## CCPS RFP#25-04 – NORTH EAST MIDDLE/HIGH SCHOOL REPLACEMENT PROJECT

### ADDENDUM #7

**This addendum is to provide the pre-bid agenda and attendance list and issued revisions to the contract documents as noted below.** Proposers and related parties will be responsible for reading and understanding all documents, the scope of work, addenda and all related solicitation documents issued. These documents will become attached to and part of the solicitation and award of bid contract.

1. **ASIs 01 and 02**
2. **PR 01**
3. **CLOSED RFIs 001- 0027, 029-031, 034. (open RFIs are excluded)**

A518

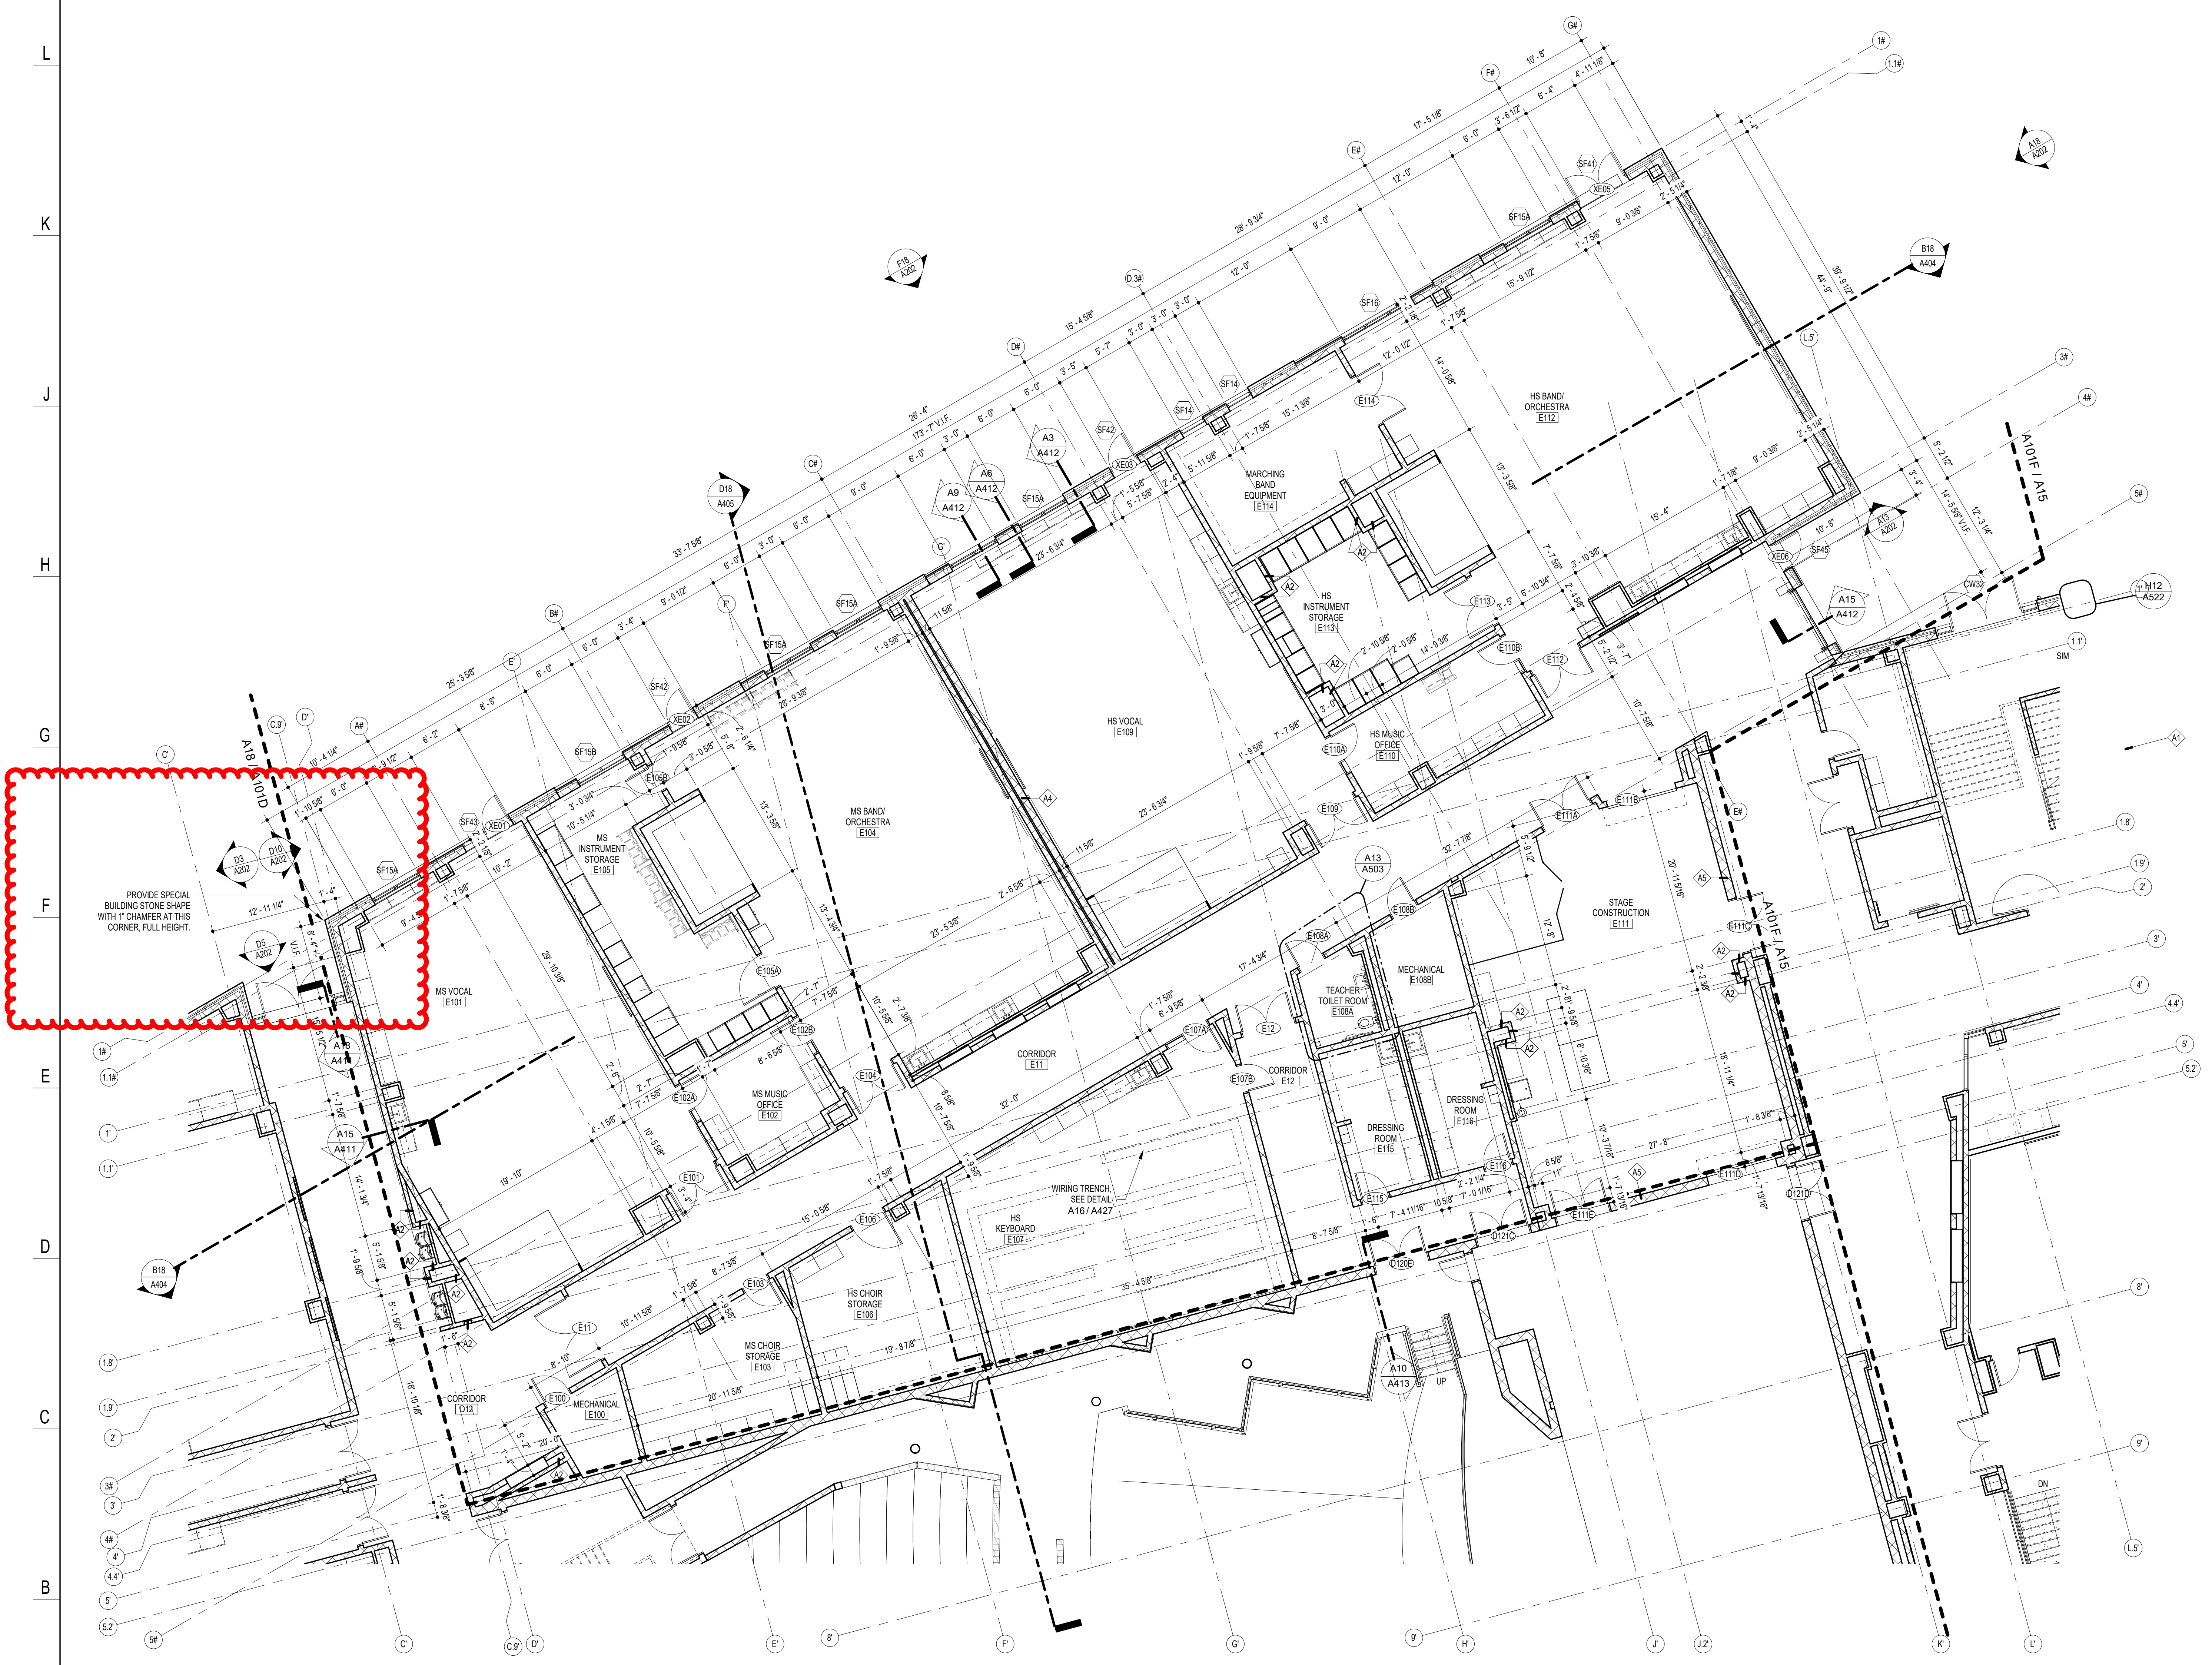
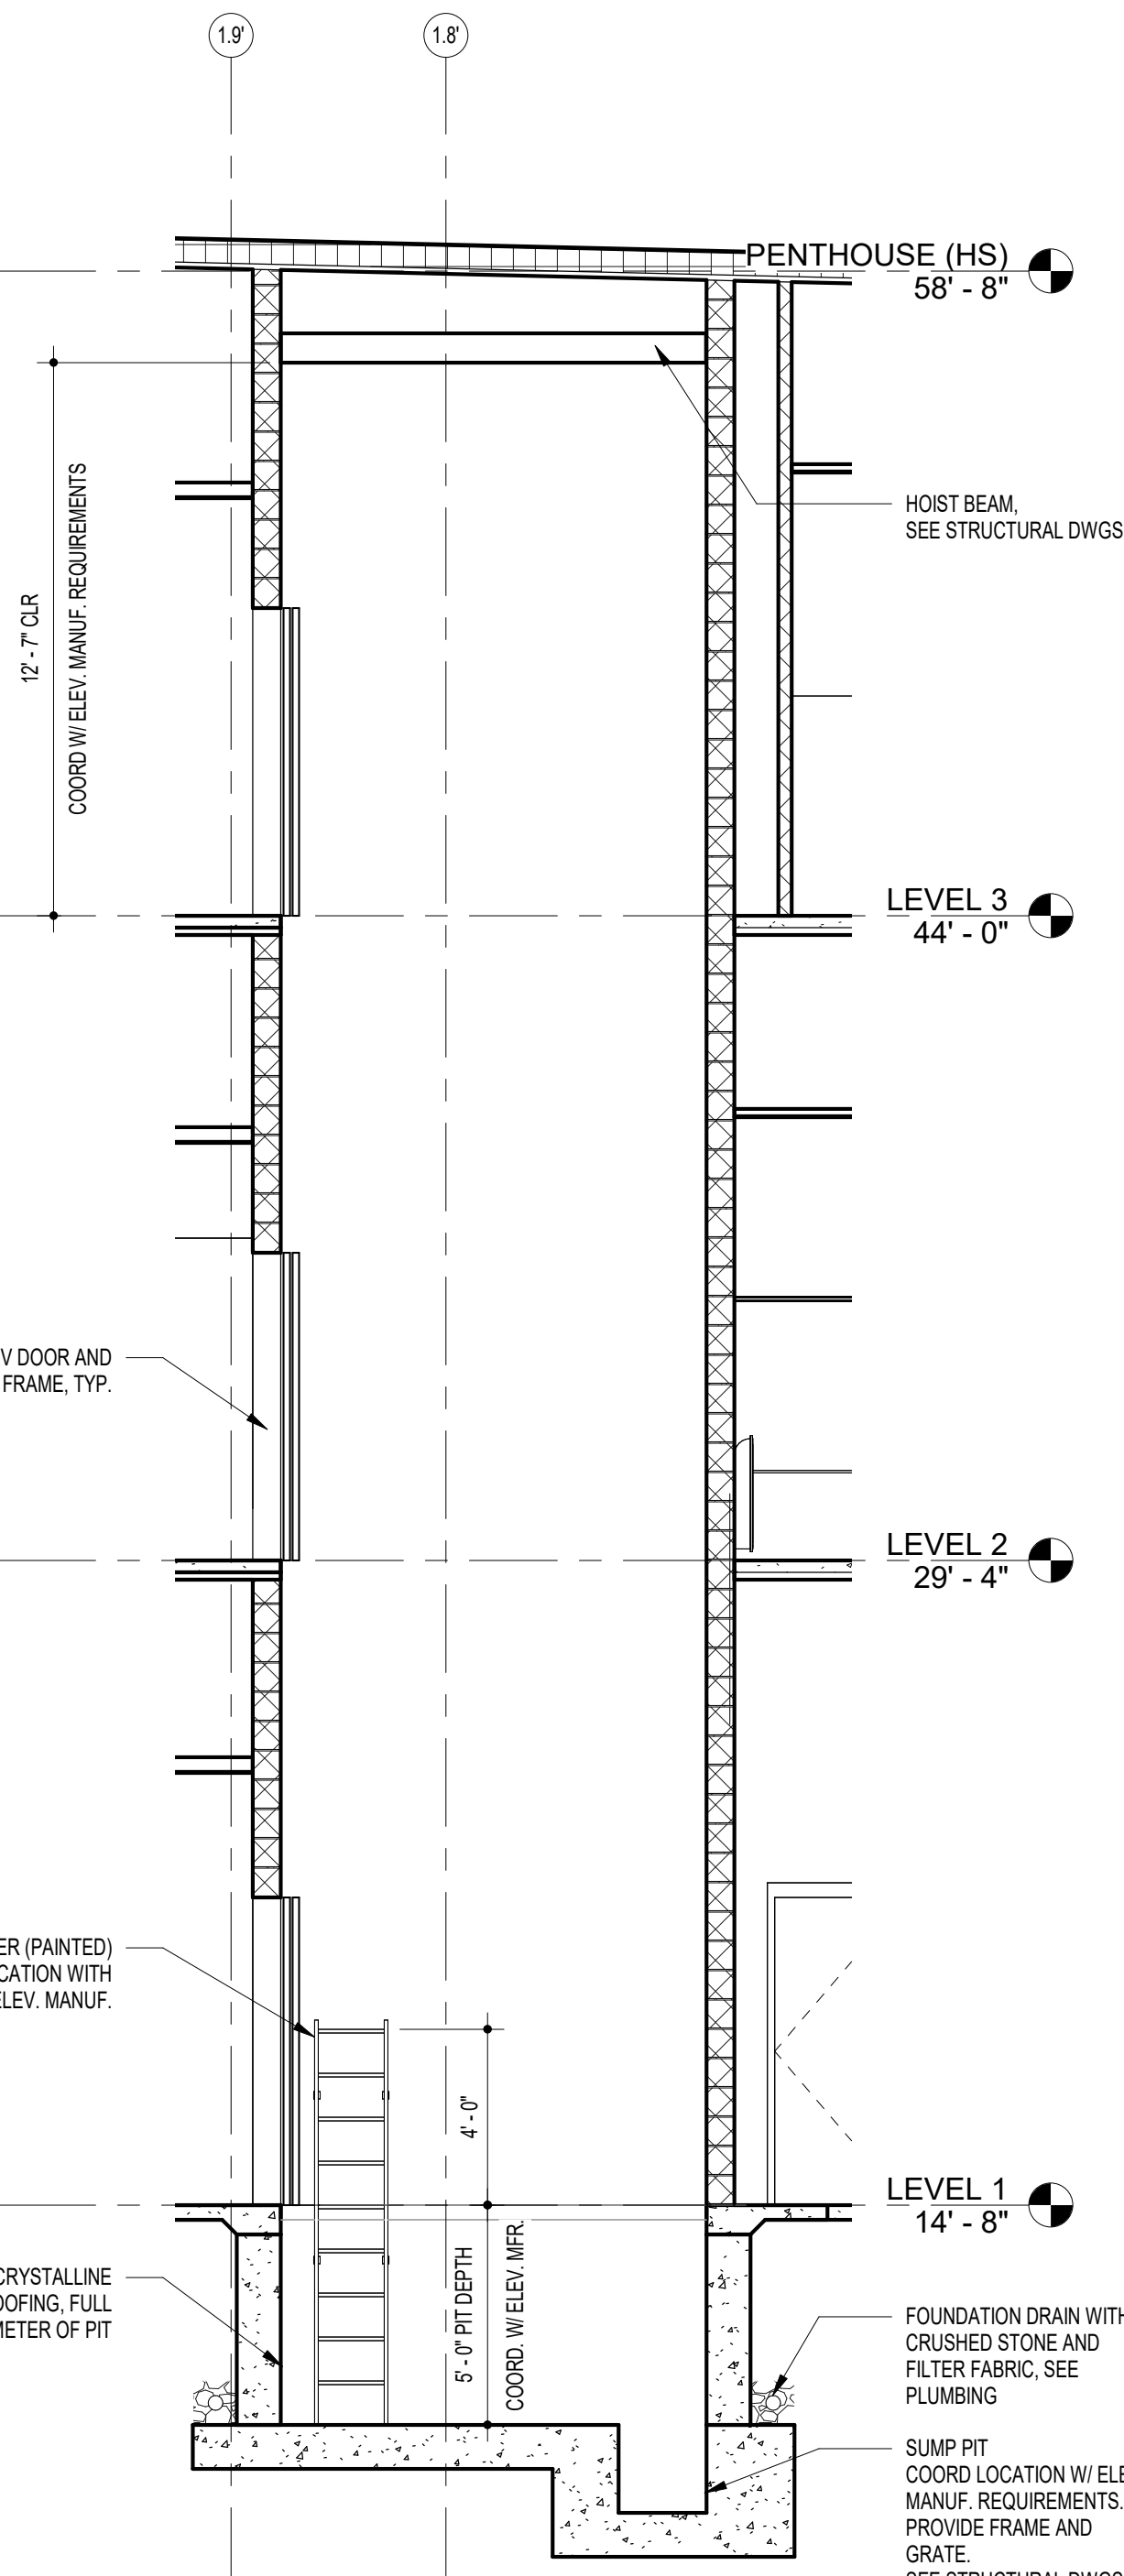
- o Sill A18/A425
- o Obtuse corner A101D (A'/1#) - please provide angle (105deg?)
- o Acute corner A101D (CL-C'/1#)- please provide angle (75deg?)
- o Obtuse corner K10/A519- please confirm 105deg angle
- o Obtuse corner H4/A518- please confirm 105deg angle
- o Please note that the chamfered building stone call out on sheet A101E (at corner CL-D'/1#) cannot be manufactured. Please confirm use of a straight joint is acceptable.

1. See attached detail on sheet A425 for dimensions.
2. 105 degree interior angle is correct.
3. 75 degree interior angle is correct.
4. 105 degree interior angle is correct.
5. 105 degree interior angle is correct.
6. Use of straight joint is not acceptable. We are working with the manufacturer on the creation of a custom cast piece and will advise of final solution.
